Service Letter: 454

Title: Improved Cabin Heat

Models: 8KCAB (AEIO-390-A1B6 engine, serial numbers 1185-2020 and prior)
8GCBC (IO-390-A1B6 engine, serial numbers 602-2020 and prior)

Figure 1, Insert Tubes

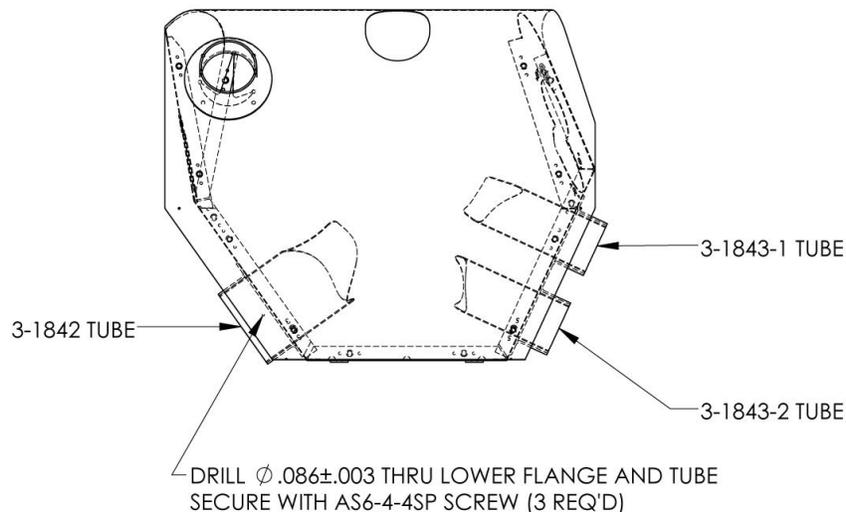
Addition of Insert Tubes:

1. Open left and right cowl doors (8 camlocks).
2. Remove cable ties securing landing light harness to lower cowl (2 ties, left side).
3. Remove lower cowl (15 screws).
4. Remove scat tubes from exhaust shroud (3 clamps).
5. Remove lower shroud screws (8 screws) to access interior of shroud.
6. Insert 3-1842, 3-1843-1, and 3-1843-2 tubes into flanges as shown in figure 1. Tubes to be snug in flanges and positioned ¼ inch away from the exhaust tubes (trim insert tubes for clearance as required). Drill $\varnothing.098\pm.003$ hole thru flange and insert tubes (drill from bottom). Secure insert tubes in flange with #4 x ¼ PK screw (1 screw per tube).

7. Reinstall lower shroud panel (8 screws) and scat tubes (3 clamps)
8. Reinstall lower cowl in accordance with AMM. Secure landing light wires with VUVT-06M or equivalent cable ties (2 each required). Close left and right side cowl door (8 camlocks).

Figure 2, Shroud Seals

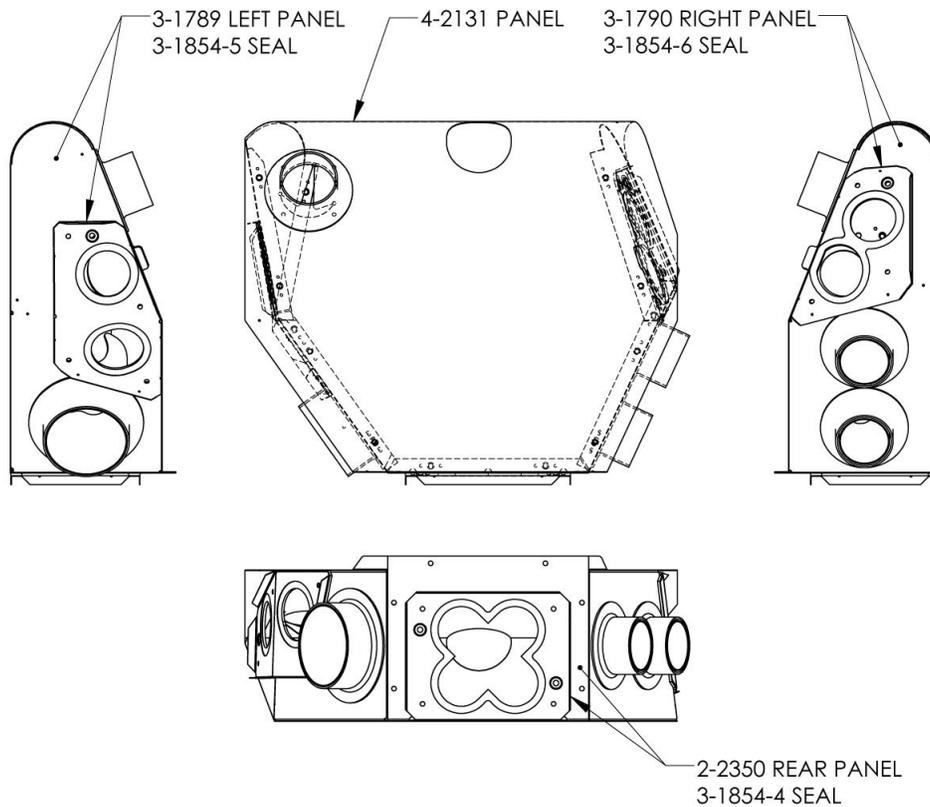
Addition of Shroud Seals and Insert Tubes:

1. Remove and disassemble exhaust and shroud per the AMM.
2. Replace 3-1791 shroud with revision A or later approved revision (component parts of the shroud are shown in figure 2 to aid with assembly). Discard original shroud components.

3. Assemble shroud and exhaust per service letter 451 and the AMM. Refer to figure 2 for the location of shroud components.
4. Install exhaust on engine per the AMM.
5. Install 3-1842, 3-1843-1, and 3-1843-2 insert tubes as described in prior section.
